Docket Number 50-346

Serial Number 3198

April 12, 2007

Subject: Davis-Besse Nuclear Power Station
License Amendment Application for Measurement Uncertainty Recapture
Power Uprate (License Amendment Request No. 05-0007)

Bases Figure 2.1 Pressure/Temperature Limits at Maximum Allowable Power for Minimum DNBR

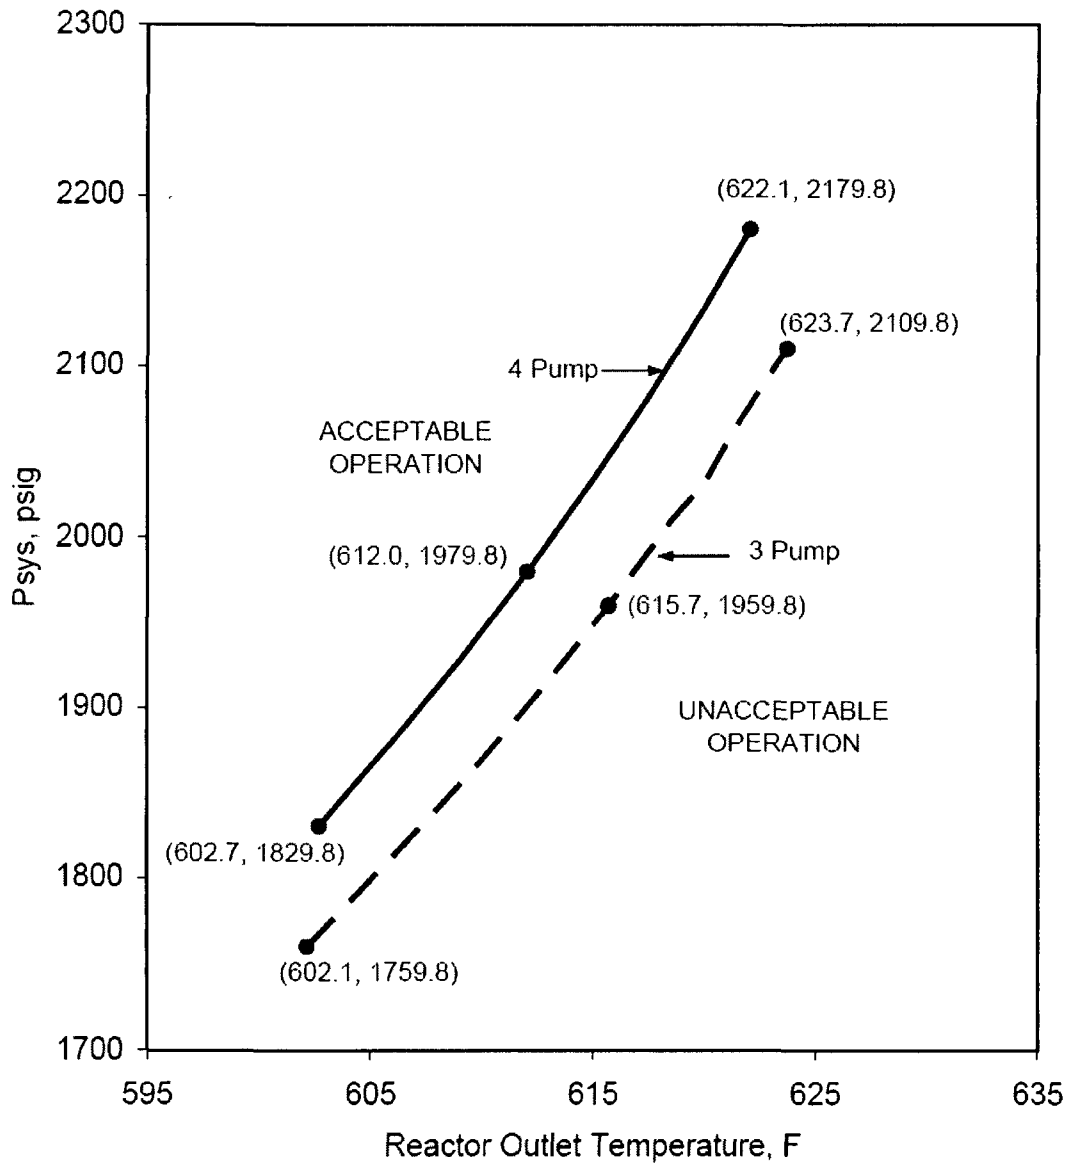
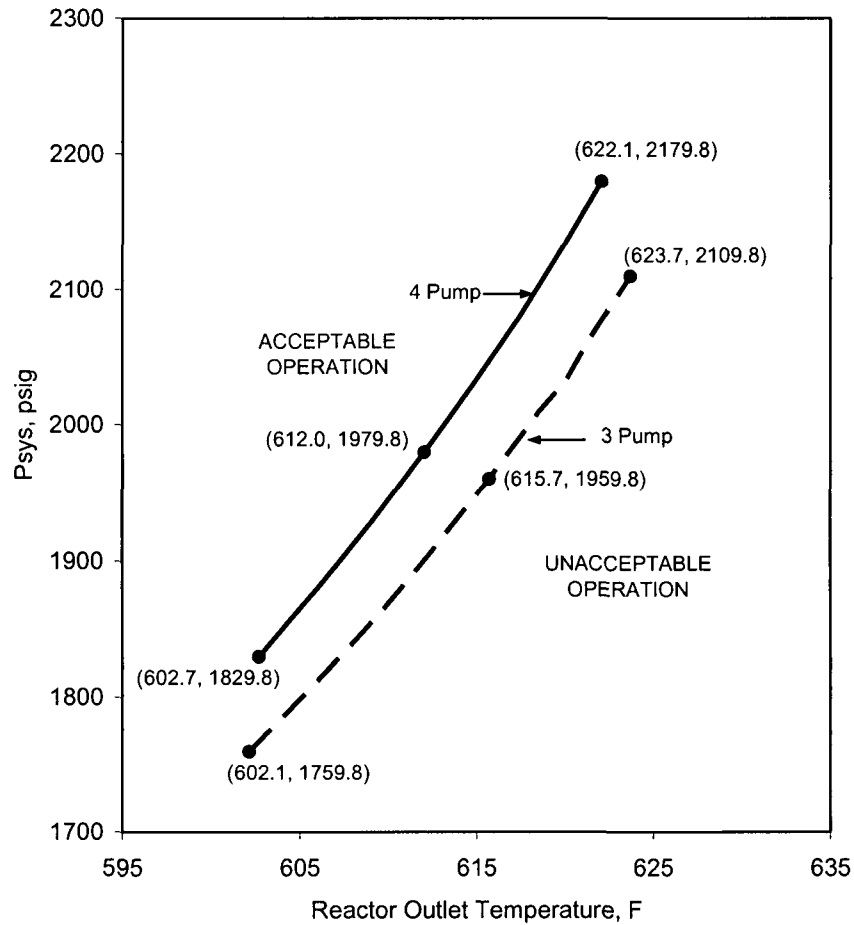
6	<p>TS B 2.0 Safety Limit Bases, Section 2.2, Page B 2-8</p> <p>Bases Figure 2.1 is replaced. The revised Bases Figure 2.1 is contained below this table.</p>
7	<p>TS 6.9.1.7, Administrative Controls – Core Operating Limits Report</p> <p>Insert as third paragraph the following:</p> <p>As described in reference documents listed in accordance with the instructions given above, when an initial assumed power level of 102% of RATED THERMAL POWER is specified in a previously approved method, an actual value of 100.37% of RATED THERMAL POWER may be used when the input for reactor thermal power measurement of feedwater mass flow and temperature is from the Ultrasonic Flow Meter. The following NRC approved documents are applicable to the use of the Ultrasonic Flow Meter with a 0.37% measurement uncertainty:</p> <p>Caldon Inc. Engineering Report-80P, “Improving Thermal Power Accuracy and Plant Safety While Increasing Operating Power Level Using the LEFM[√]™ System,” Revision 0, dated March, 1997.</p> <p>Caldon Inc. Engineering Report-157P, “Supplement to Topical Report ER-80P: Basis for a Power Uprate with the LEFM[√]™ or LEFM CheckPlus™ System,” Revision 5, dated October, 2001.</p>

The curve presented in Figure 2.1-1 represents the conditions at which a minimum DNBR equal to or greater than the correlation limit is predicted for the maximum possible thermal power of 110.2% of 2817 MWt 412% when the reactor coolant flow is 380,000 GPM, which is approximately 108% of design flow rate for four operating reactor coolant pumps. (The minimum required measured flow is 389,500 GPM). This curve is based on the design hot channel factors with potential fuel densification and fuel rod bowing effects.
